Planning & Environment Court of Queensland  
Brisbane  
No. 2916/24

## **Report for the Court on Provision of Stormwater Infrastructure**

### **For Resubdivision of 128 Ashridge Road, Darra, Queensland**

By  
Andrew Corrigan

**Brisbane City Council Contours 2002.**

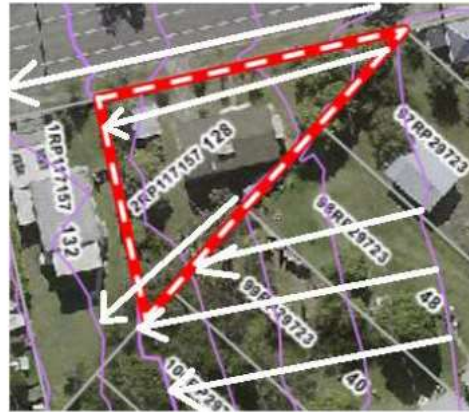
1) Contours 2002 show flow of rainwater in rear neighbours land falling downstream from on neighbour to the other rear neighbour, left of each other, rather than to the subject property. Therefore there are no "Upstream" neighbours to the subject development.

- 5.4. I note that the Applicant is using contours from 2002. As in paragraph 1 above and **Attachment B** I have used Brismaps 2019.
- 5.5. The Applicant refers<sup>2</sup> to a “recent survey by ONF Surveyors” (which I have not received). The Applicant includes on page 7 of the Assessment Report by the Applicant titled “Town Planning Application” a diagram attributed to this survey. In my opinion, the contours shown on this survey match Brismaps 2019 whereas the contours in the plan on page 6 are different. The Applicants markup on page 7 depicts the natural flow of rainwater from the middle of the subject property to the right and rear of the subject property.

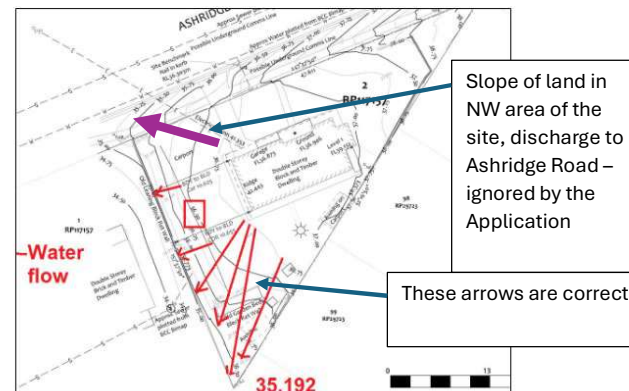
- 7.4. I disagree with aspects of the development application material as follows.
- 7.5. The text on page 7 below the Surveyors Contours states that it is proposed not to “interfere with the natural and existing flow of stormwater”. However, as I have explained, the proposed dwelling and building pad will alter the existing characteristics of the stormwater drainage through the subject lot.

- 7.6. The stormwater flow characteristics of the subject site will be altered by the a new dwelling and cause a concentration of flow into the adjacent Lot 1 to the west. The application states that the current flow will not be interfered with, but this is incorrect.
- 7.7. The conclusions stated in page 6 by the Applicant in the Assessment Report by the Applicant titled “Town Planning Application” are incorrect as follows.
- 7.7.1.1. The arrows depict that all stormwater from the subject lot discharges into the adjacent lot to the south (Lot 1) including flow from the northern side of the subject lot. This is incorrect as follows.

View of northwest corner of the site

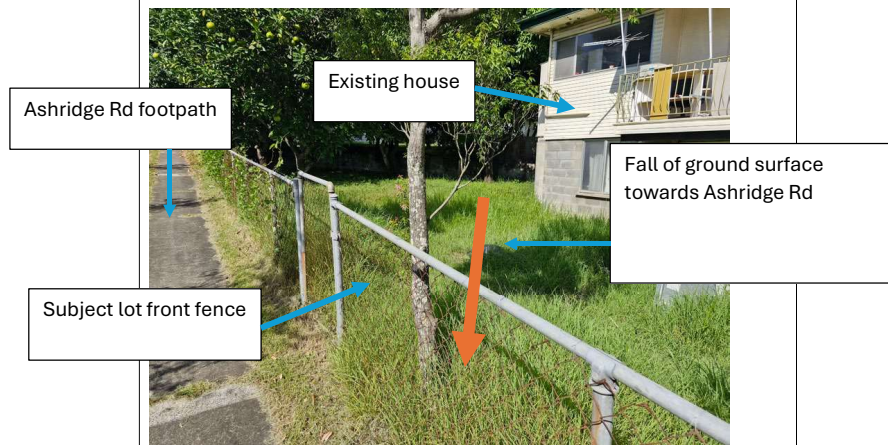
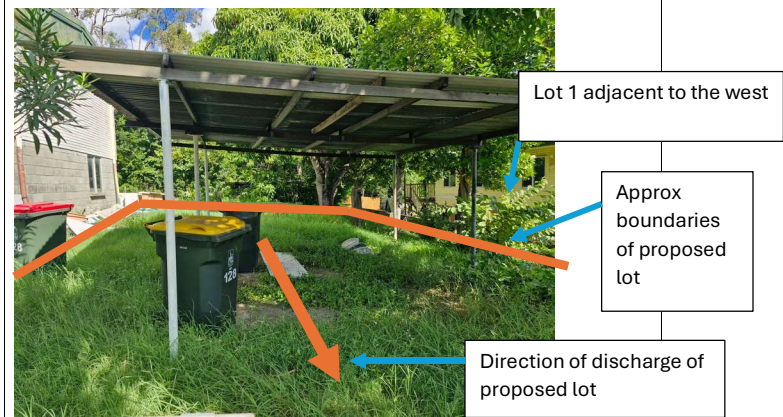
7.7.1.1.4. I took the photos below which shows the existing lot surface falling towards Ashridge Road in the northwest area of the subject lot including a substantial portion of the proposed new lot.

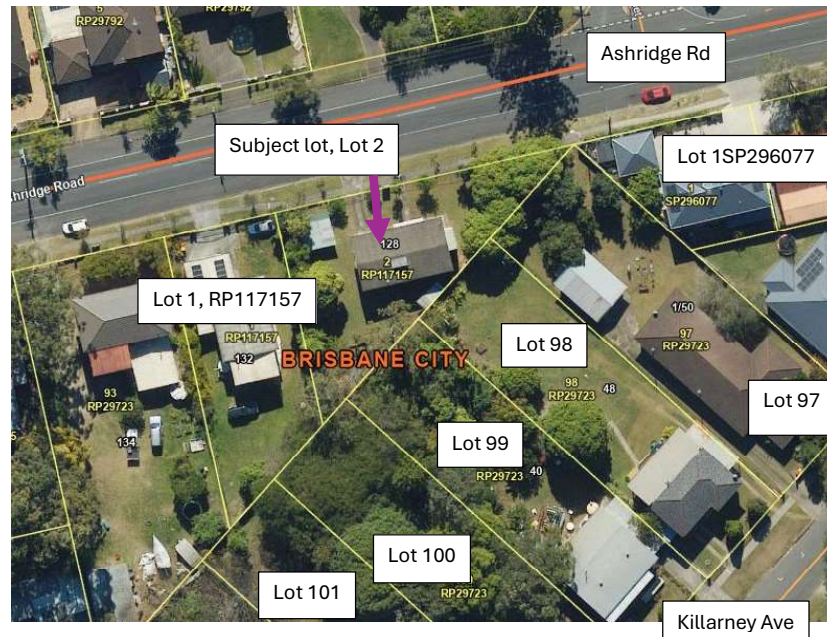
7.10.1. Whilst I agree that the existing topography allows some discharge from the subject lot to Lot 1, the proposed development will change this flow and cause concentration of discharge. As stated above, the new dwelling will act as a barrier across a substantial existing width of the flow path towards Lot 1.

7.10.2. This result would not comply with PO2 of 9.4.9 Stormwater Code of the Planning Scheme.

- 7.10.3. I disagree with the statement that the topography along the western side of Lot 2 prevents stormwater runoff to be conveyed naturally and freely to Ashridge Road. The contour plan (paragraph 1.2 above) shows that the northern part of the western boundary of Lot 2 does have topography that causes stormwater to flow into the Lot and away from Ashridge Road. However, the southern part of the western boundary has topography that allows natural stormwater flow from Lot 2 towards Ashridge Road. I also observed this topography when I walked past the site and took photos. The contours show topography that allows a substantial portion of Lot 2 to drain naturally to Ashridge Road. Where Civil Works Engineers states that "all of Lot 2" discharges to Lot 1, this is incorrect.

- 7.10.4. Even if the existing discharge from all of Lot 2 was into Lot 1 (with which I disagree), then the development would trigger the requirement to prevent worsening or change of flow into Lot 1 to ensure compliance with PO2, PO3 and PO4 of 9.4.9 Stormwater Code of the Planning Scheme. The solution would be to create discharge to Ashridge Road.

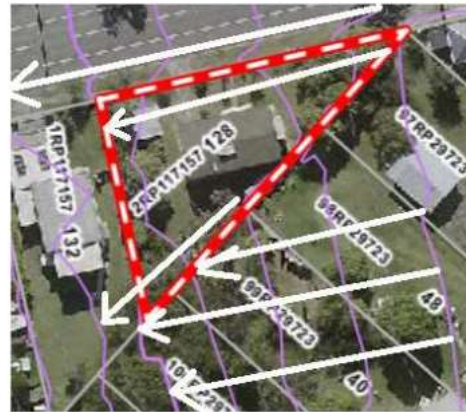
8.12.2.1. The plan on page 6 (excerpt below) shows stormwater from Lots 98 and 99 discharging towards the subject lot. However, the stated conclusion by the Applicant (in the text above the plan) is that the contours show flow to the “left” of the subject property and concludes that “there are no “Upstream” neighbours to the subject development”. This is incorrect as follows.

8.12.2.1.1. The discharge from Lot 97 has been ignored (the contours show that Lot 97 slopes towards the subject lot).

8.12.2.1.2. Discharge from the western triangular areas of Lots 98,99 and 100 flows into the subject lot and not south of it. The arrows on Lots 98, 99 and 100 are correct but the text above the plan contradicts these arrows.
